Subject: Zoning By-law Amendment – 1546 Scott Street

File Number: ACS2023-PRE-PS-0072

Report to Planning and Housing Committee on 7 June 2023

Document 5 – Proposed Site Plan

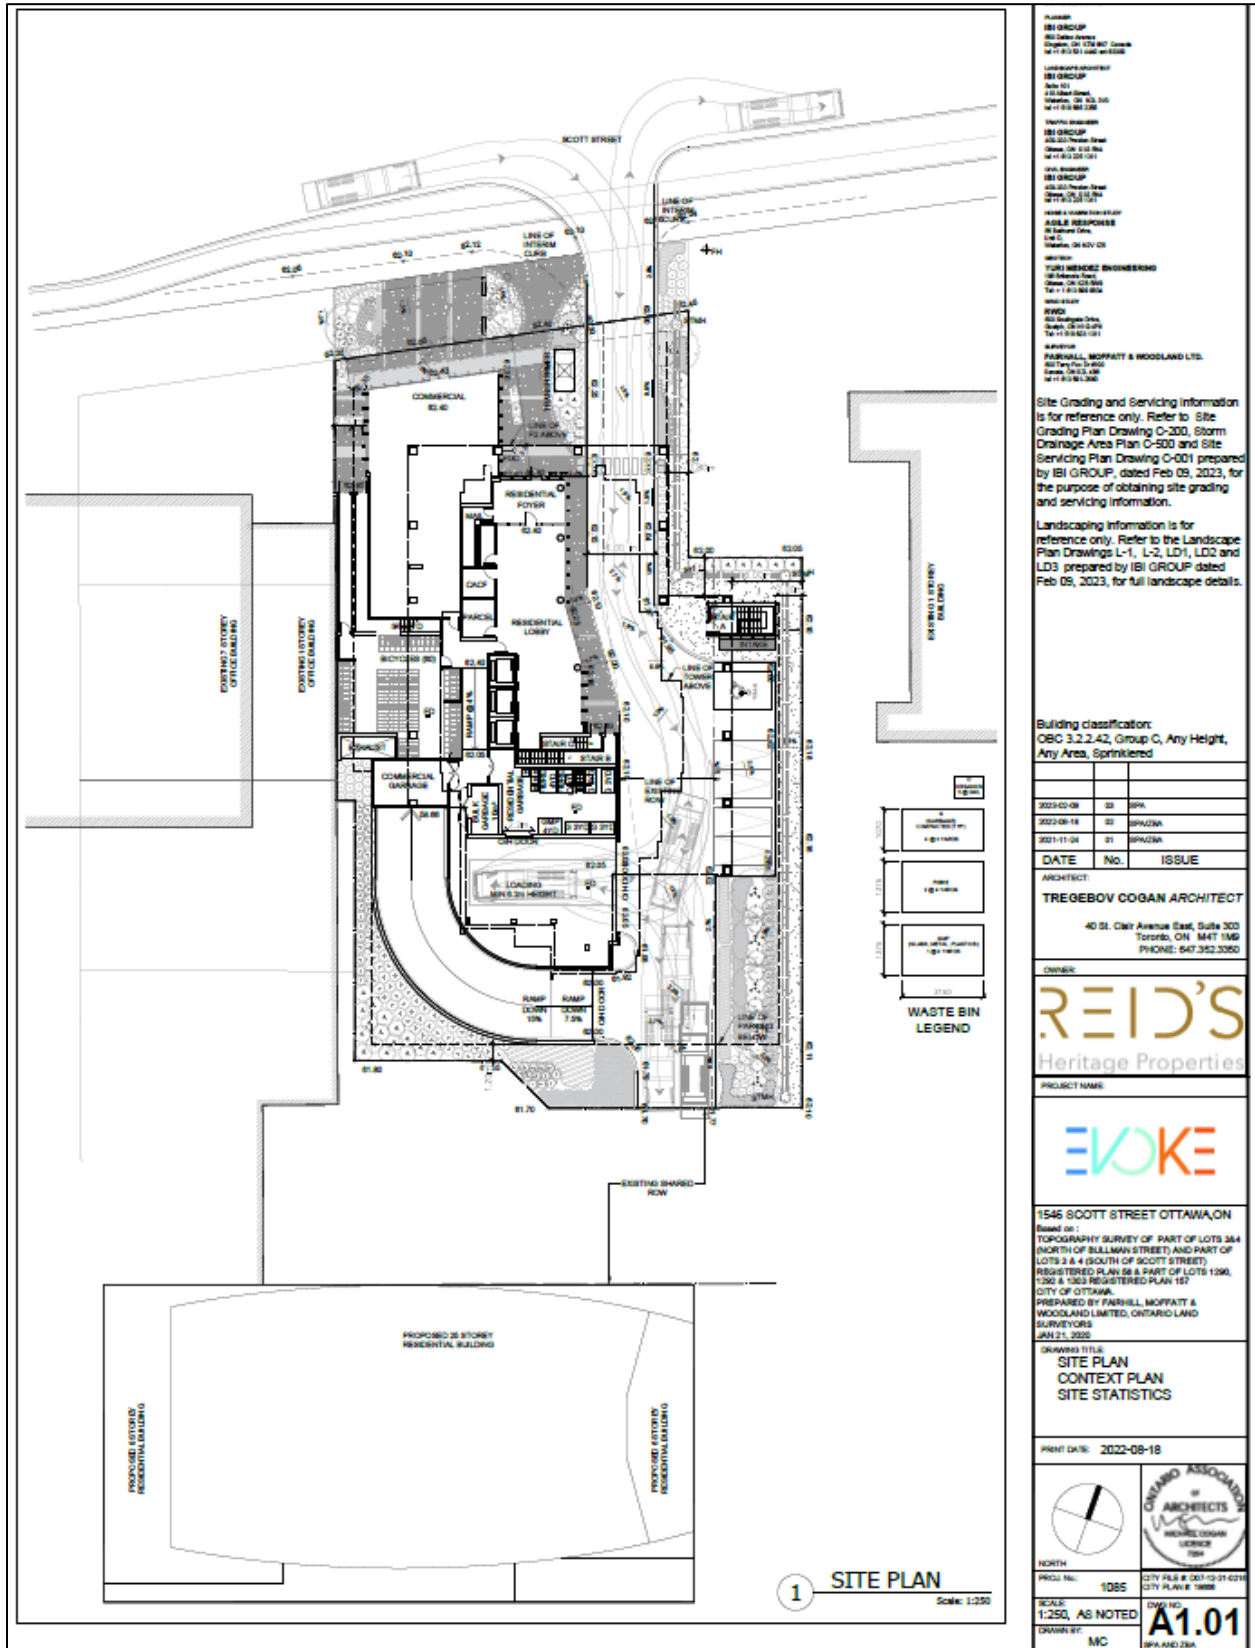
- The Panel appreciates the proposed walkway and the consideration given to the future development on the adjacent property; however, the walkway is tucked behind the stairs making it difficult for pedestrians to navigate and know where to cross, which could result in pedestrians using the driveway to connect through the block. The Panel recommends moving the crossing further north for better visibility.

- The site plan indicates that the access to the garbage and loading area is through the pedestrian crossing; the proponent should consider a different treatment for the crossing and have it lit to ensure the walkway is safe for pedestrians.

- The Panel questions the location of the exterior stairs as there are some safety concerns; the proponent should consider its location and treatment through a CPTED lens and relocate the transformer.

- The Panel recommends the proponent consider a high-quality pedestrian paving treatment across the front of the property, through both the plaza and driveway to unify and strengthen the public realm.
